ADDENDUM NO. 1

RE: Item #2, May 7, 2025 Letting - PT 0025(98)26, ER 0044(253)368, ER 019A(34)28, PT 0044(223)397, PCN 0828, 0A2Y, 0A37, 0829, Hutchinson, Turner County - Scour Protection, Berm Repair, Bank & Channel Protection

CHANNEL CROSS SECTIONS (B)

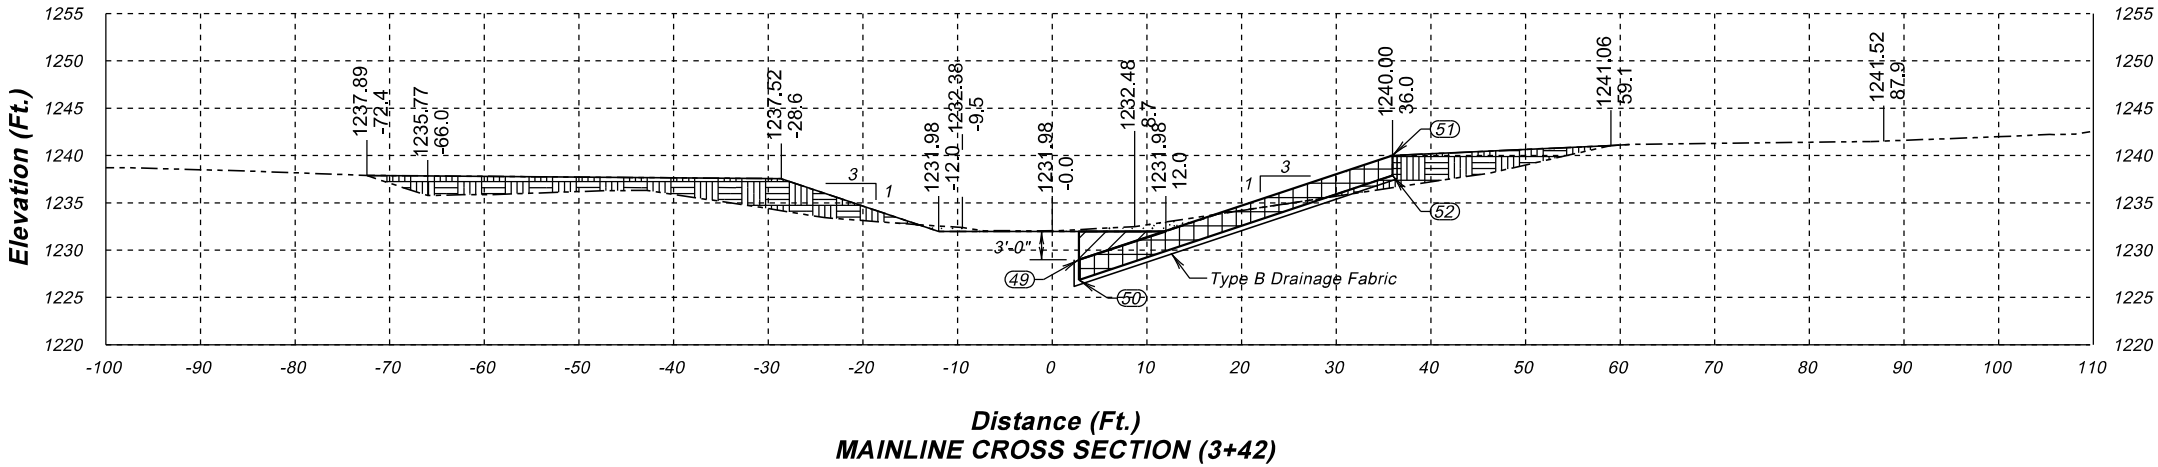
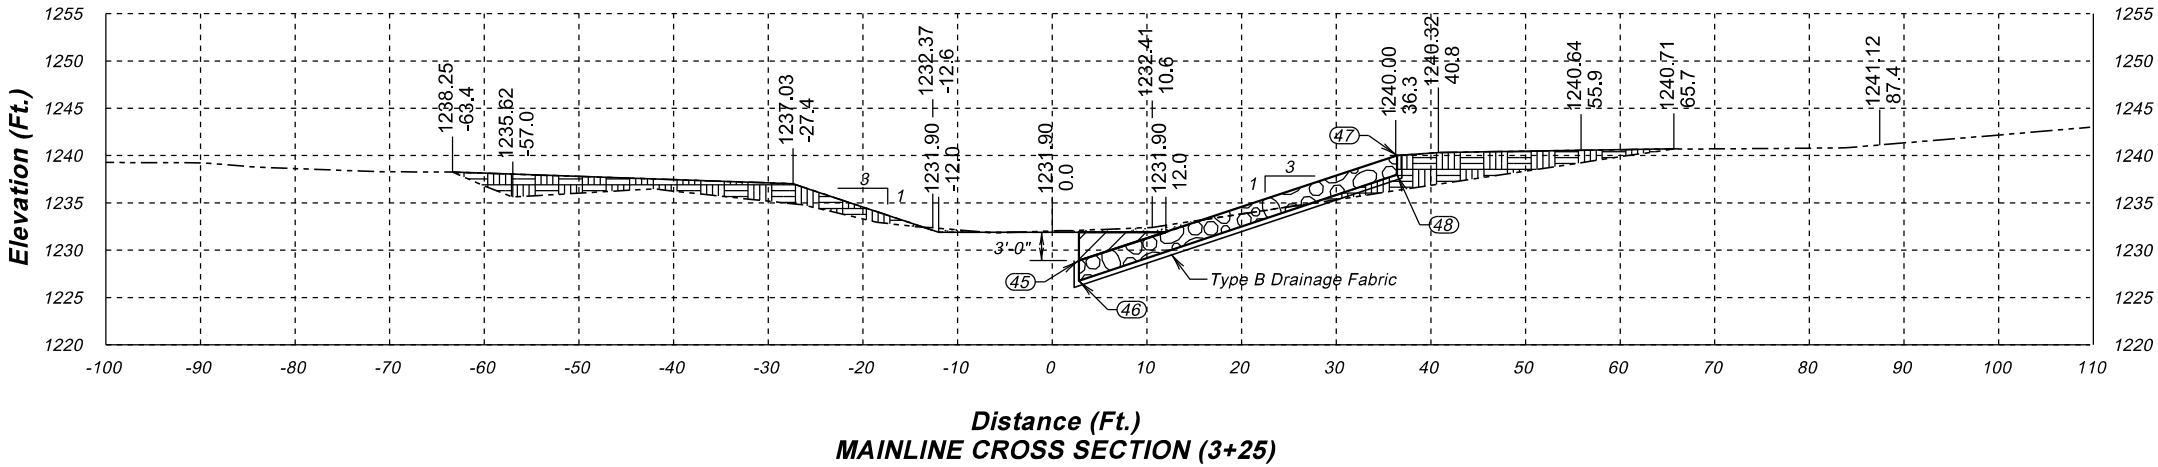
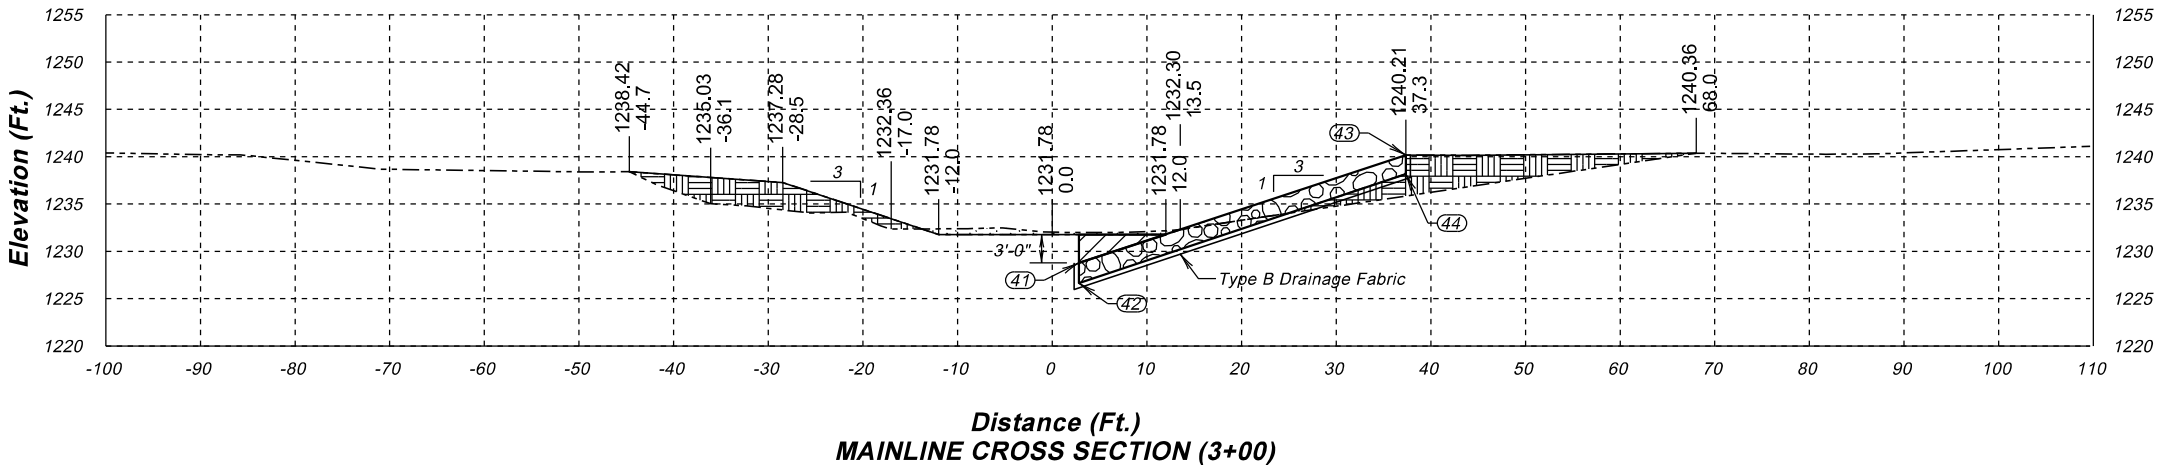
Sheets 24 & 28: Cross Sections were revised to show fully grouted riprap location.
